Waterfront - Union St. Pedestrian Bridge

Project Description

This was the Seattle Design Commission's (SDC) third review of the Waterfront - Union St Pedestrian Bridge project. The purpose of this meeting was to review the design development (90% design) phase for the project. The SDC also reviewed the design details that were conditioned during the January 3, 2019 review of the Marketside Flats Skybridge project. The SDC voted, 5-1, to approve the design development phase for the Waterfront - Union St Pedestrian Bridge project with several recommendations. The SDC then voted to approve the condition of the January 3rd, 2019 approval of the public benefits package for the Marketfront Flats Skybridge.

Design Development (90%)

Figure 2: Proposed design of the pedestrian bridge and surrounding area

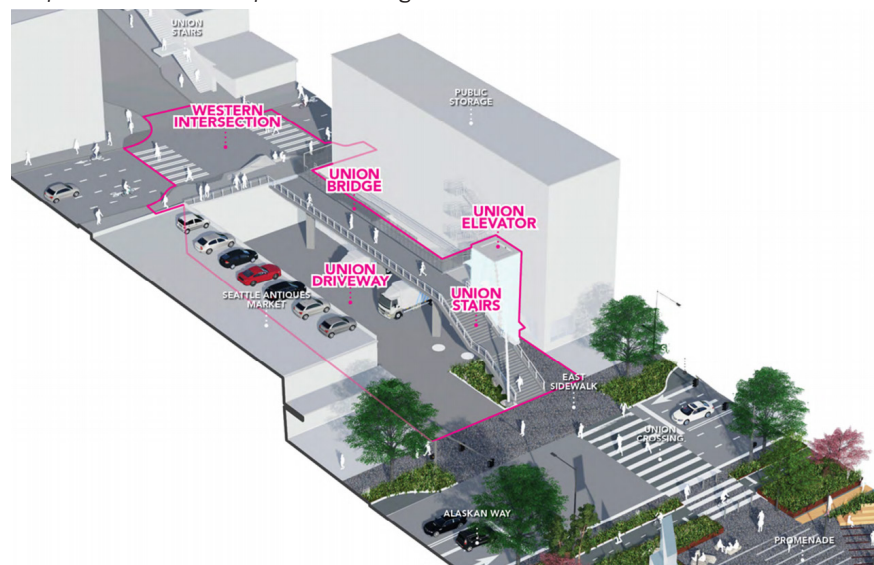
The SDC recommended the project team reconsider the design of the Western Ave intersection. Specifically, Commissioners recommended the team reconsider the design of the bench as well as visual sight lines between the intersection, pedestrian bridge, and elevator.

The commission asked what analysis was done of the wall and why it was not being replaced with this project. The team responded that replacement of the wall is not within the project definition. The criteria is to design the project to not impart additional load to the wall. An analysis will confirm the loads from the improvements on Western Avenue meet the “due no harm” tolerances of the existing wall.

The SDC questioned the use of concrete paving material on Union St and recommended the project team consider using asphalt as a cost saving measure. The Commission also recommended the project team provide clarification of the beacon element and its relationship with surrounding lighting elements.

The SDC supported the use of the elevator tower as a beacon but acknowledged that it was in conflict with the proposed artwork. Commissioners encouraged the project team to consider lighting the elevator shaft in way that will not conflict with the adjacent artwork.

The Commission then commented that the intersection should include an overlook to provide a place for users to pause. The SDC then recommended that the design of the intersection be reviewed at a subcommittee meeting.

1. Return for a subcommittee to review the design of the Western Ave intersection, specifically the proposed design of the bench
2. Provide further clarification of the beacon element
3. Provide further clarification of paving materials; consider the use of asphalt for cost savings
4. Provide further information on the retaining wall
